5148 M 2001

GROUP 1
FUEL CELL LOCATIONS

AS-BUILT CONDITIONS

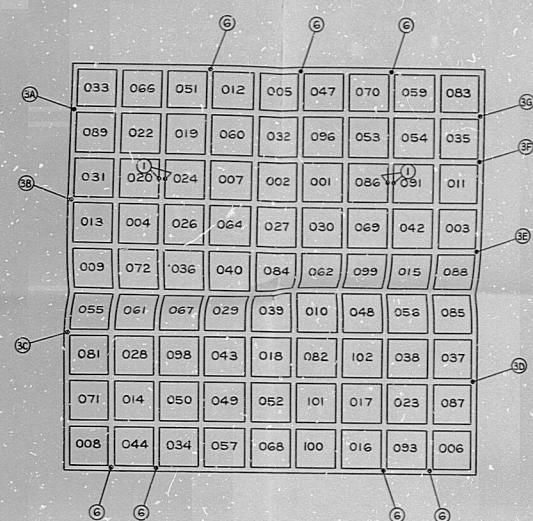
- NCR 82-41 ① ITEM IS ADAPTER BARS DELETED AT THE 4 LOCATIONS MARKED.
- NCR 82-45 ② CELLS SHOWN EXCEED PLUMBNESS TOLERANCE AS FOLLOWS:
*035 - .055 OVER TOLERANCE *083 - .055 OVER TOLERANCE
*033 - .025 OVER TOLERANCE

- NCR 82-53 ③ ACTUAL LENGTHS OF 3.0 DIM. (ZONE E-6, SHT. 1) FOR NOTED LOCATIONS ARE AS FOLLOWS:
A - 2.700 B - 2.950 C - 2.920 D - 2.845
E - 2.790 F - 2.900 G - 2.910

- NCR 82-54 ④ FUEL CELL INSIDE DIMENSION (7.00±.03) IS OVERSIZE IN ONE DIRECTION TO THE DEPTHS SHOWN BELOW:
- | CELL # | ACT. DIM. | DEPTH | CELL # | ACT. DIM. | DEPTH | CELL # | ACT. DIM. | DEPTH |

- ADDITIONAL CELLS THAT EXCEED THE 7.03 DIMENSION IN ONE DIRECTION ARE SHOWN BELOW:
- | CELL # | ACT. DIM. | CELL # | ACT. DIM. | CELL # | ACT. DIM. |

- NCR 82-55 ⑤ CELL PITCH 9.00±.06 IS EXCEEDED AS FOLLOWS:
- | CELL TO CELL | ACT. DIM. | CELL TO CELL | ACT. DIM. |

- NCR 82-64 ⑥ AT LOCATIONS SHOWN, TOLERANCE ON 4.0±.1 DIM. (ZONE E-6, SHT. 1) IS INCREASED TO ±.2

GROUP 2
FUEL CELL LOCATIONS

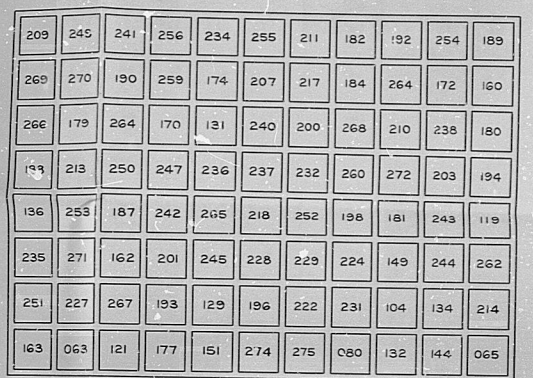
- NCR 82-13 ① FUEL CELL DIMENSION (7.00±.03) IS OVERSIZE IN ONE DIRECTION AT DISTANCES DOWN FROM LEAD-IN ON THE FOLLOWING CELLS:
- | CELL # | ACT. DIM. | DIST. DN. FR. LEAD-IN | CELL # | ACT. DIM. | DIST. DN. FR. LEAD-IN |

- NCR 82-39 ② IN ADDITION THE FOLLOWING CELLS ARE OVERSIZE BUT NONE EXCEED THE 7.05 DIM. SPECIFIED FOR *132:
- | CELL # | ACT. DIM. | CELL # | ACT. DIM. | CELL # | ACT. DIM. |

- NCR 82-27 ③ FUEL CELL DIMENSION (7.00±.03) IS UNDERSIZE IN ONE DIRECTION ON THE FOLLOWING CELLS:
- | CELL # | ACT. DIM. | CELL # | ACT. DIM. |

- NCR 82-58 ④ TOLERANCE INCREASED ON 5.0±.1 DIA. (ZONE D-1, SHT. 1) TO ±.1 (NOTE: 6 CELLS ONLY AFFECTED)
- NCR 82-71 ⑤ CELL PITCH 9.00±.06 MEASURES 8.875 AT FOUR LOCATIONS ONLY. (LOCATIONS NOT CLEARLY SPECIFIED ON NCR)

- NCR 82-103 AM ⑥ 1/8" CAN SEAM WELD (ZONE D-1, SHT. 1) ARE UNDERSIZE ON THE FOLLOWING CELLS:
- | CELL # | ACT. DIM. | CELL # | ACT. DIM. | CELL # | ACT. DIM. |

- NOTE: WORST CASE IS 3/32" WELD ON CELL *234.
- NCR 82-114 ⑦ CELL TO CELL PITCH (9.00±.06 INDIVIDUAL & ±.120 ACCUMULATIVE) IS EXCEED AS FOLLOWS:
- | CELL TO CELL | ACT. DIM. | CELL TO CELL | ACT. DIM. | | |

GROUP 3
FUEL CELL LOCATIONS

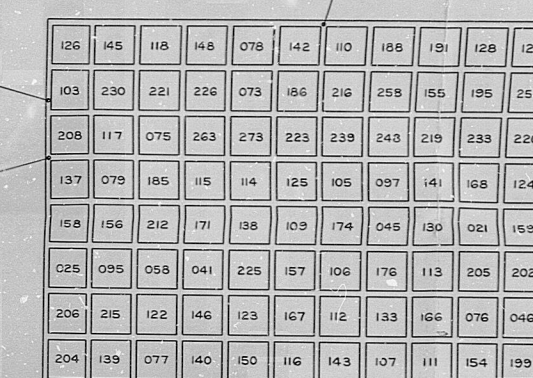
- NCR 82-33 ① FUEL CELL DIMENSION (7.00±.03) IS OVERSIZE ON CELL *176. ACTUAL DIMENSION IS 7.050
- NCR 82-100 ② ADDITIONAL CELLS THAT EXCEED THE 7.03 DIMENSION ARE SHOWN BELOW:

- NCR 82-43 ③ THE 4.00±.06 DIM. (ZONE E-7, SHT. 2) IS OUT OF TOLERANCE AT LOCATIONS SHOWN. ACTUAL DIMENSIONS ARE A. 3.937 B. 4.080 C. 4.080
- NCR 82-92 ④ FUEL CELL DIMENSION (7.00±.03) IS OVERSIZE ON THE FOLLOWING CELLS:

- NCR 82-93 ⑤ CELL TO CELL PITCH (9.00±.06 INDIVIDUAL & ±.120 ACCUMULATIVE) IS EXCEEDED AS FOLLOWS:
- | CELL TO CELL | ACT. DIM. | CELL TO CELL | ACT. DIM. | | |

- NCR 82-106 ⑥ 1/8" CAN SEAM WELD (ZONE D-1, SHT. 1) ARE UNDERSIZE ON THE FOLLOWING CELLS:
- | CELL # | ACT. DIM. | CELL # | ACT. DIM. | CELL # | ACT. DIM. |
